Crescent Parklands 1 Crescent Street, Holroyd

RTS Package

Prepared for Tiberius (Holroyd) Pty Ltd (as trustee for the Holroyd Unit Trust)
March 2026

Public & Private Space

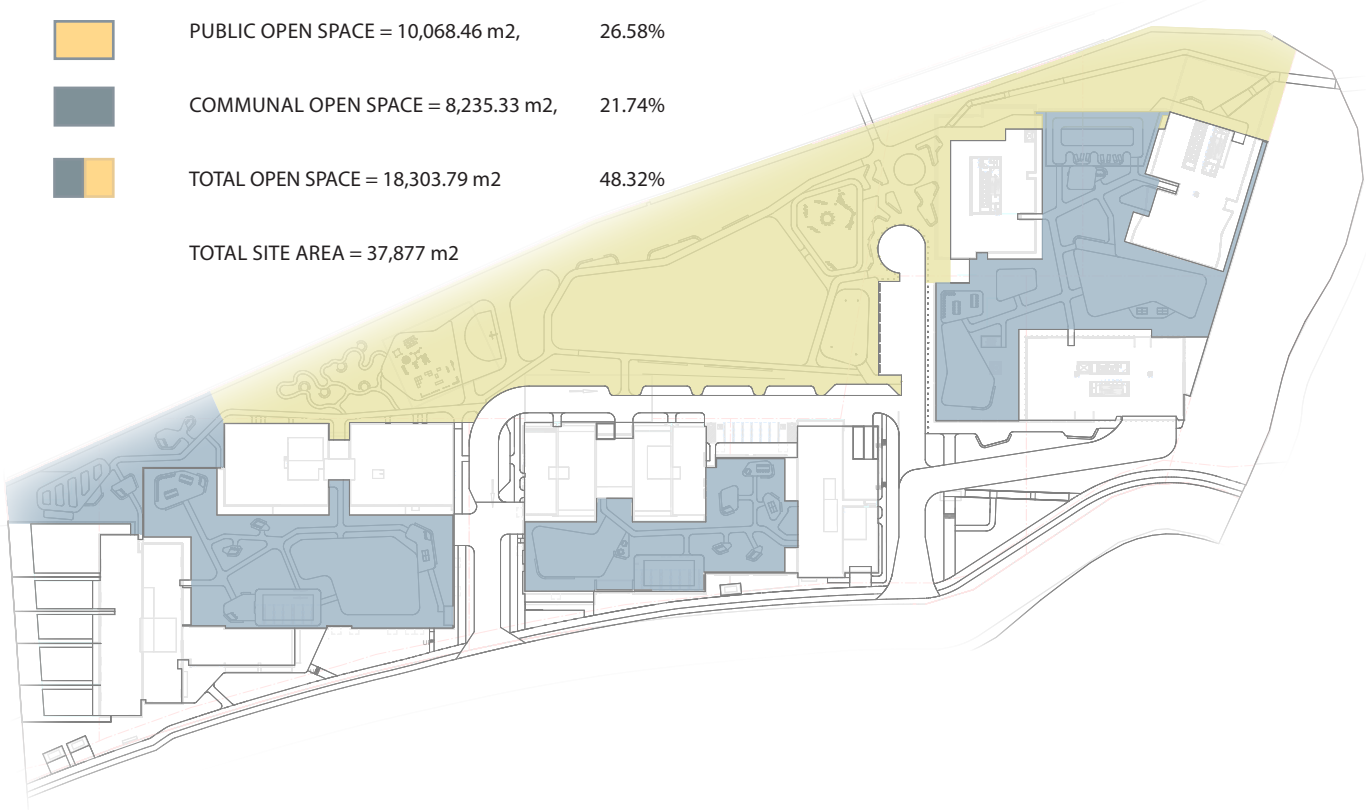
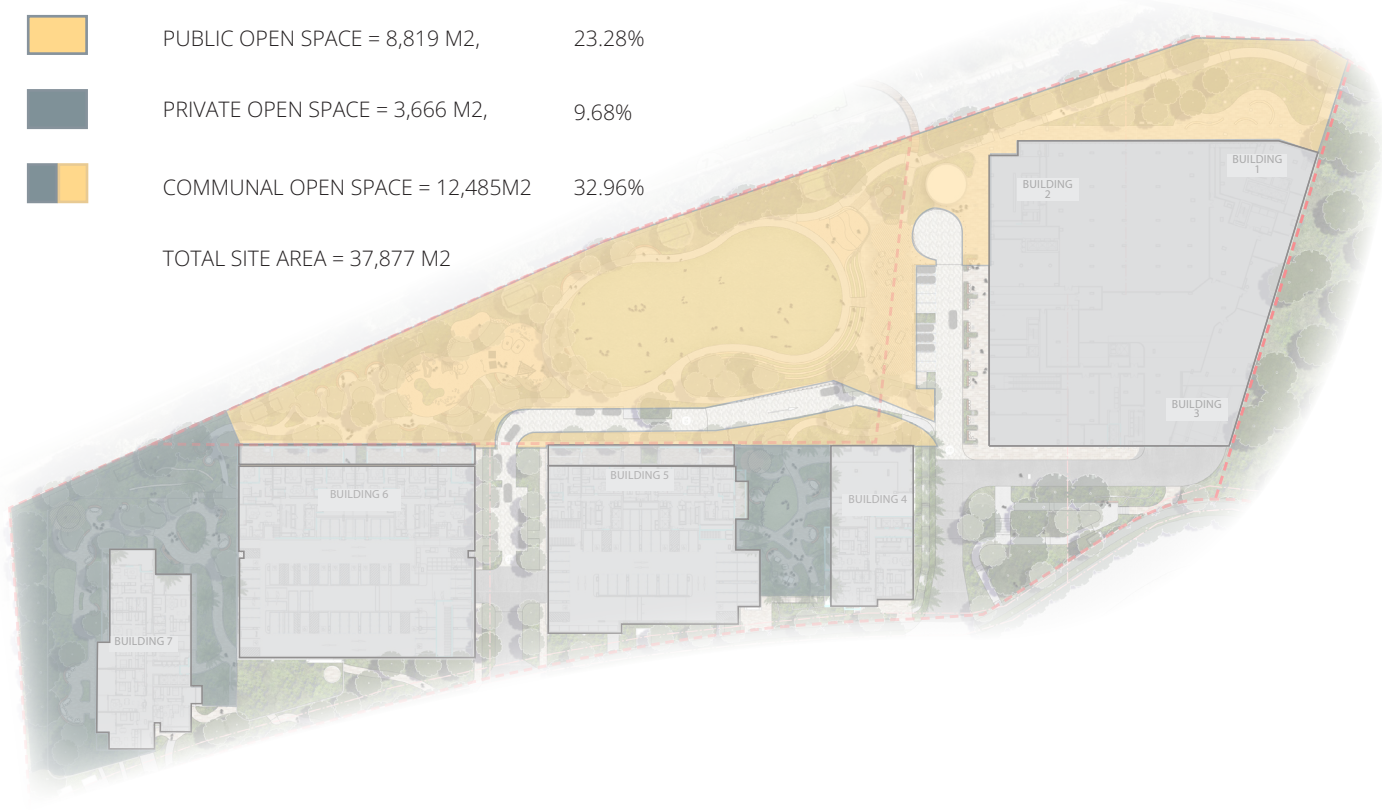
h) update the ‘Ground Floor Public and Private Space’ diagram and calculations (p26) to take account of any landscaping amendments made in response to this letter.
(Refer to Page 22)

PUBLIC OPEN SPACE = 10,068.46 m2,	26.58%
	COMMUNAL OPEN SPACE = 8,235.33 m2,	21.74%
	TOTAL OPEN SPACE = 18,303.79 m2	48.32%
TOTAL SITE AREA = 37,877 m2

PUBLIC OPEN SPACE = 8,819 M2,	23.28%
	PRIVATE OPEN SPACE = 3,666 M2,	9.68%
	COMMUNAL OPEN SPACE = 12,485M2	32.96%
TOTAL SITE AREA = 37,877 M2

Connection to Country Opportunities

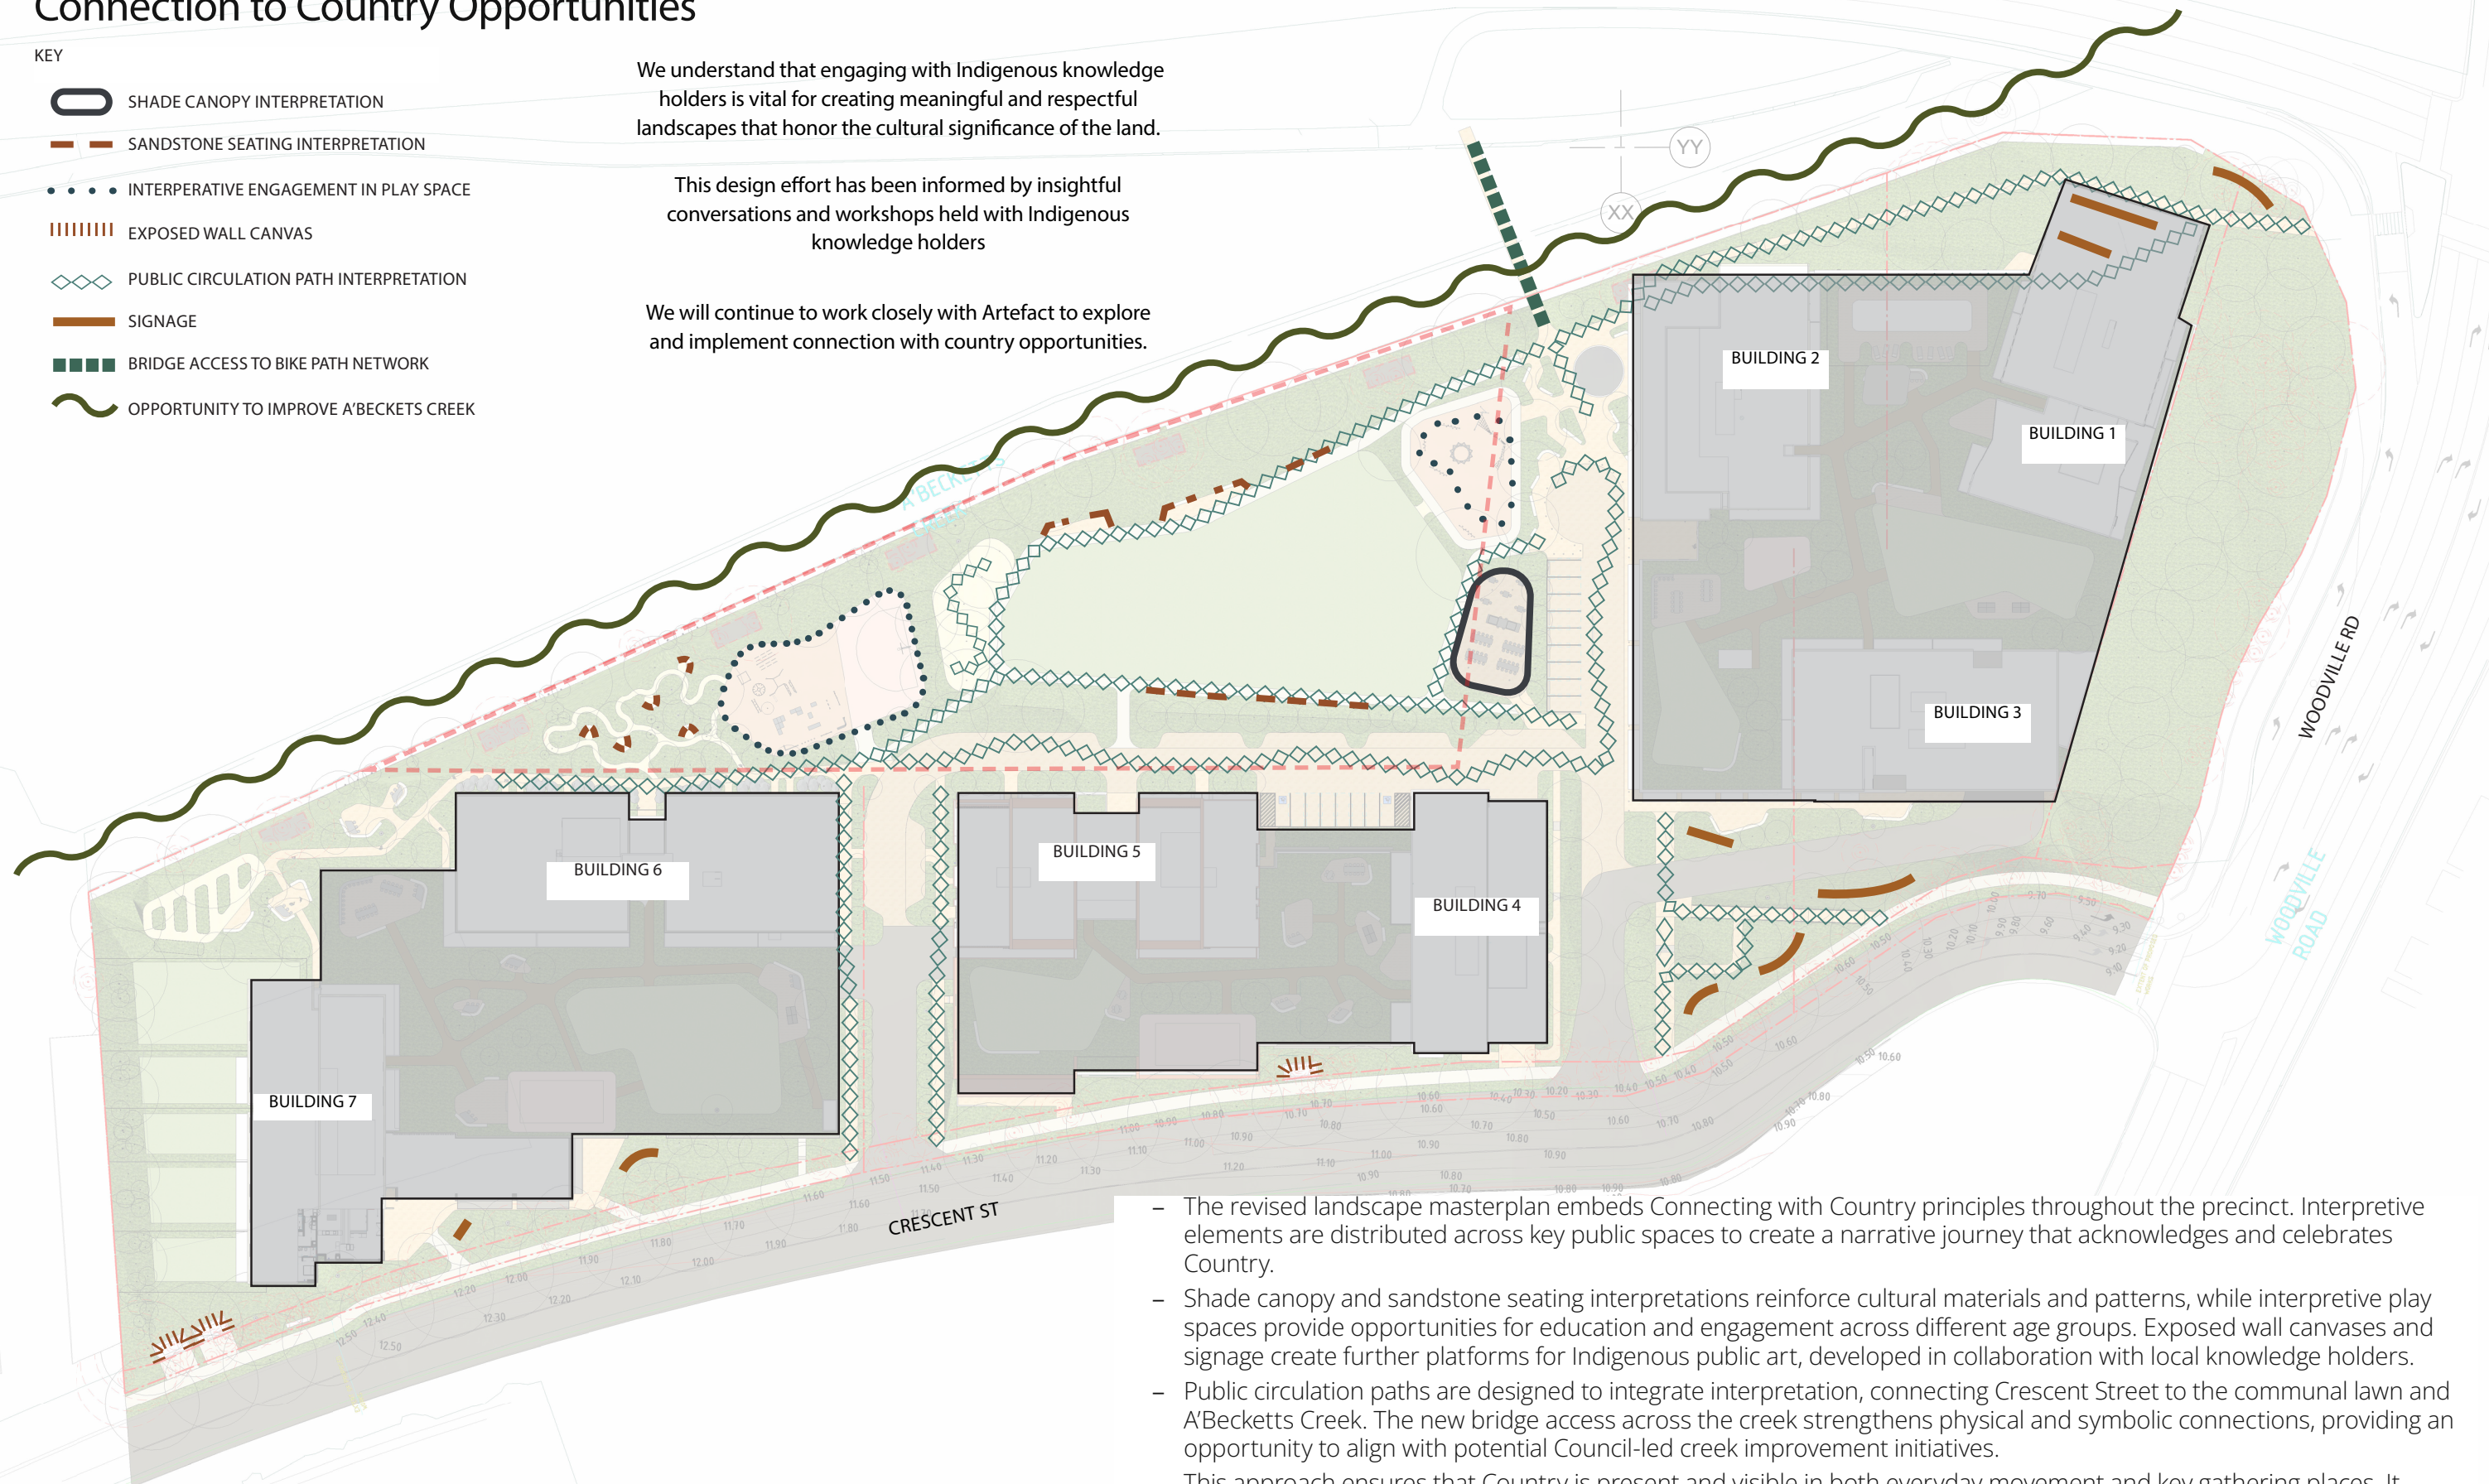
SDRP-18 Provide a response to the SDRP (Meeting 3) comments 2, 3, 4, 5 and 9. See below for each comment required for response. 2. Connecting with Country: the Designing with Country elements will be resolved and identify where there are opportunities for co-design during later stages . The Connecting with Country report establishes a comprehensive framework for ongoing co-design opportunities throughout the project’s development stages. The report identifies specific “Designing with Country” elements that require further resolution through collaborative processes with Aboriginal knowledge holders. The previously submitted report nominated specific recommendations from consultation workshops, including collaborative eel designs on A’Becketts Creek bridge, integration of seasonal calendars and cultural narratives into interpretive elements, and incorporation of traditional plant knowledge into landscape design. Aboriginal stakeholders emphasised authentic storytelling that moves beyond generic motifs to reflect genuine connections to Burramattagal Country. Key co-design opportunities identified include development of a Heritage Interpretation and Public Art Strategy requiring stakeholder consultation, integration of meaningful co-designed interpretation and artwork elements, and facilitation of ongoing design workshops with Aboriginal stakeholders during subsequent development stages. Moving forward, the proponent has committed to implementing the report’s recommendations for ongoing stakeholder engagement and ensuring all cultural integration follows Indigenous Cultural Intellectual Property protocols established through extensive community engagement. 3. Connecting with Country: an understanding of Country is being realise in the open space areas and along Crescent St. The Connecting with Country report provides specific guidance for embedding cultural understanding into landscape design, emphasising the importance of pathways as traditional “maroo” that connected communities across Country for visiting family, collecting food, and conducting ceremonies. Aboriginal stakeholders highlighted during consultation the significance of creating welcoming spaces that acknowledge Burramattagal Country and tell the stories of place. With consideration of the

- The revised landscape masterplan embeds Connecting with Country principles throughout the precinct. Interpretive elements are distributed across key public spaces to create a narrative journey that acknowledges and celebrates Country.

- Shade canopy and sandstone seating interpretations reinforce cultural materials and patterns, while interperative play spaces provide opportunities for education and engagement across different age groups. Exposed wall canvases and signage create further platforms for Indigenous public art, developed in collaboration with local knowledge holders.

- This approach ensures that Country is present and visible in both everyday movement and key gathering places. It reflects ongoing consultation with Indigenous stakeholders and lays the foundation for future collaboration to deliver meaningful cultural expression in the detailed design phase.
